DEPARTMENT OF ENVIRONMENTAL PROTECTION
DIVISION OF WATER MONITORING AND STANDARDS

ADOPTED AMENDMENT TO THE UPPER DELAWARE WATER QUALITY
MANAGEMENT PLAN AND SUSSEX COUNTY WATER QUALITY MANAGEMENT
PLAN

TO ADOPT FOUR TOTAL MAXIMUM DAILY LOADS FOR PHOSPHORUS IN THE
PEQUEST RIVER WATERSHED, WATERSHED MANAGEMENT AREA 1,
NORTHWEST WATER REGION, AS LISTED IN TABLE 1

Summary of Public Comments and the Department's Response

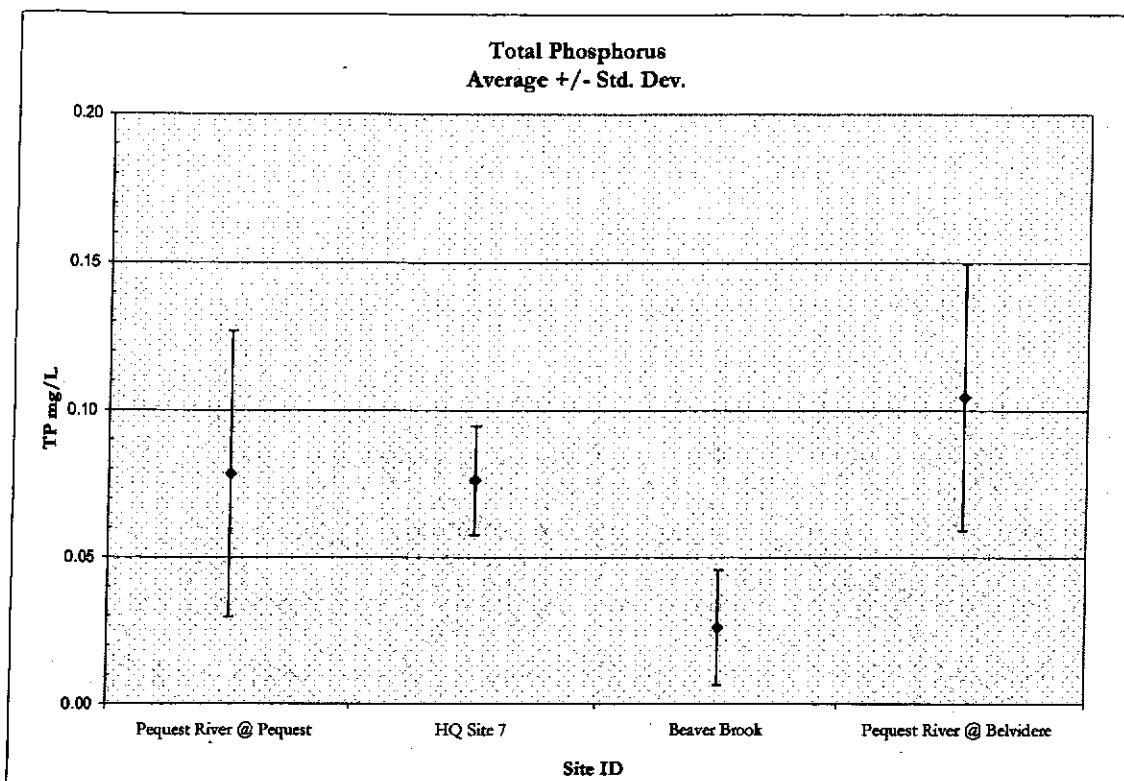
Comment 3: The TMDL is incomplete in that it does not include all total phosphorus impaired waters within the Pequest River watershed. Only 4 out of 5 Assessment Units were addressed. Given the available data, a comprehensive total phosphorus TMDL including all of the total phosphorus impaired Assessment Units appears feasible. The costs for additional data collection may be placed on the Warren County Municipal Utilities Authority. Additionally, the TMDL for the remaining Assessment Unit might result in a more stringent WLA and effluent limits, when it is complete. A more practical procedure would be to complete the TMDL study for the entire Pequest River rather than proceed with the piecemeal approach that the proposed total phosphorus TMDL represents. Based on the amount of available data for the Assessment Unit, there needs to be a credible reason, aside from "needs additional study", to explain why all of the impaired Assessment Units have not been addressed. (2)

Response to Comments 2 and 3: The statement in the TMDL that additional study is required to address the "Pequest River below Furnace Brook (02040105090060-01)" Assessment Unit was based on an evaluation of water quality data sampled within and at the boundary of this assessment unit. The Department found that the data collected to date is insufficient to properly characterize all sources within this assessment unit.

Total phosphorus data was collected under low flow conditions, defined as that flow which is exceeded 70% of the time, at several locations: Pequest River at Pequest (USGS station ID 01445500) located at the boundary of this assessment unit (AU), HydroQual Site 7, Beaver Brook (USGS station ID 01445495), and the most downstream location: Pequest River at Belvidere (USGS station ID 01446400). The graph below shows the total phosphorus concentrations at the sites listed above. Because sampling was done during low flow conditions, storm driven loads can be ignored for this illustration. Starting from the left, with the most upstream location, the total phosphorus concentrations at Pequest River at Pequest were compared to the next downstream location, HydroQual Site 7, and the concentrations were found to be similar, with an average total phosphorus concentration of 0.078 mg/L and 0.076 mg/L, respectively.

Considering the distance of 4.5 miles between these two sites, attenuation of the phosphorus load should result in total phosphorus concentrations at HQ Site 7 that would be notably lower than those at the boundary of this assessment unit. This suggests that there is a source of total phosphorus between these two sites. Proceeding downstream, total phosphorus concentrations from Beaver Brook are quite low; many of the total phosphorus data are below the detection limit. Despite this dilution from a higher quality source, total phosphorus concentrations at Pequest River at Belvidere show an increase, with total phosphorus concentrations exceeding 0.1mg/L. This suggests, again, a source between the confluence of Pequest River and Beaver Brook and the Pequest River at Belvidere site.

The Department concluded that in order to address this remaining impaired assessment unit, additional sampling within this impaired assessment unit is needed to better understand and characterize the sources and the needed reductions. Any additional sampling required to address the remaining impaired assessment unit will not be the obligation of the Warren County MUA. It is not unique to this TMDL to have related downstream impaired assessment units deferred because of a need for further study or to address a downstream assessment unit separately from upstream assessment units. In this latter case, the Department assumes that criteria for the parameter of concern are met at the upstream boundary entering the assessment unit. Because TMDL implementation would attain SWQS, it is expected that no further reduction would be required in upstream areas, particularly since it appears that there is a significant uncharacterized source in the downstream impaired assessment unit. However, no guarantees can be given about future requirements as the Department will need to assess the effectiveness of the TMDL over time and may need to employ adaptive management principles to address lack of success. This could include assigning revised WLAs to upstream sources. In any case, upgrades at this time have value in that they are needed to restore water quality.
